STATE OF WASHINGTON
DEPARTMENT OF ECOLOGY

February 10, 2017

Re: Further Action at the following Site:

- **Site Name:** 318 State Ave NE Olympia
- **Site Address:** 318 State Ave NE, Olympia, Thurston County
- **Facility/Site No.:** 3024394
- **Cleanup Site No.:** 2010
- **VCP Project No.:** SW1013

Figure 1

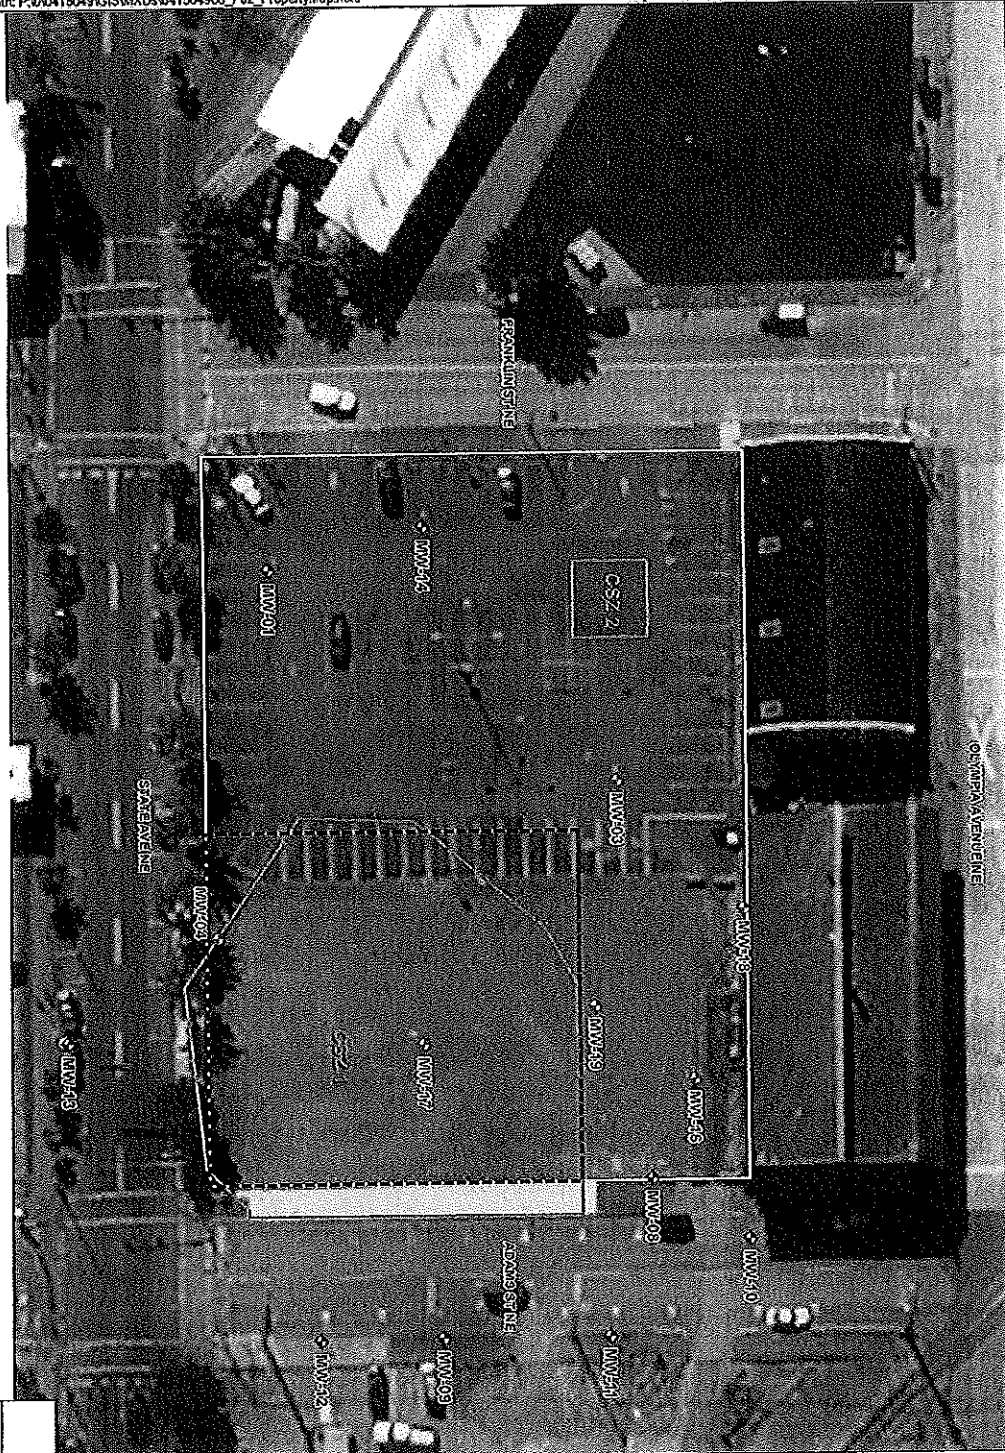
- 4) With regards to groundwater monitoring before, during, and after the injections, Ecology requests that you consider the following:
 - a. Ecology concurs that the well network should be sampled prior to initiating the injections in order to establish a recent baseline of pre-injection conditions at the Site (Figure 1).

Treatment Area	
318 State Avenue NE Olympia, Washington	
	Figure 2

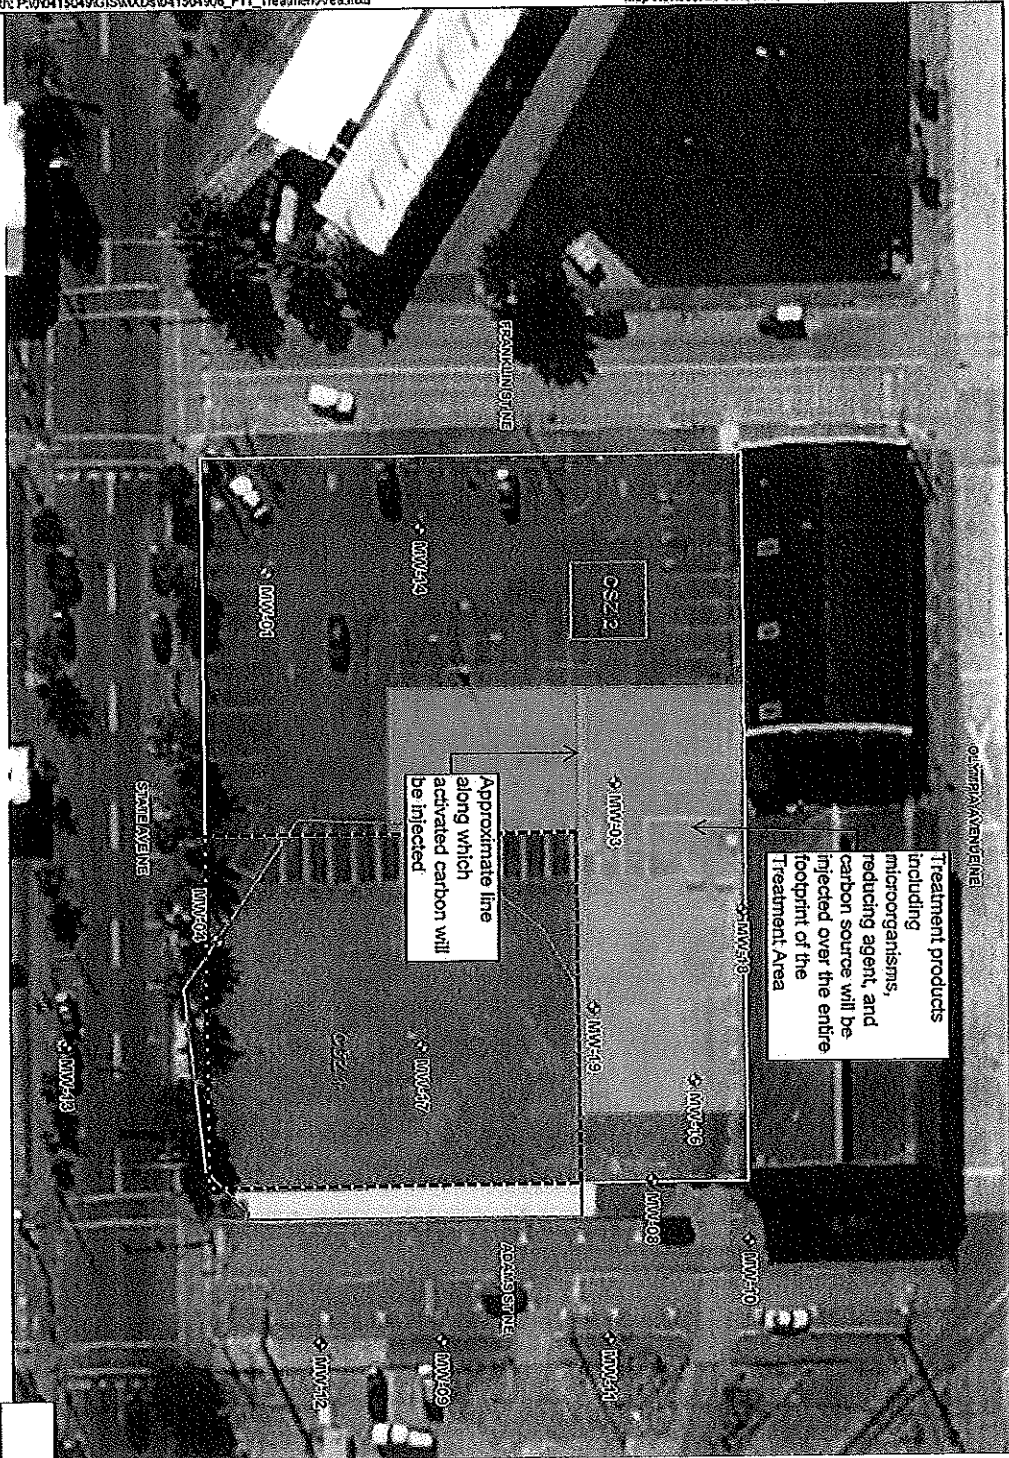
- b. Ecology concurs that MW-01 is the background well to use for determining background conditions at the Site before, during, and after injection (Figure 2).
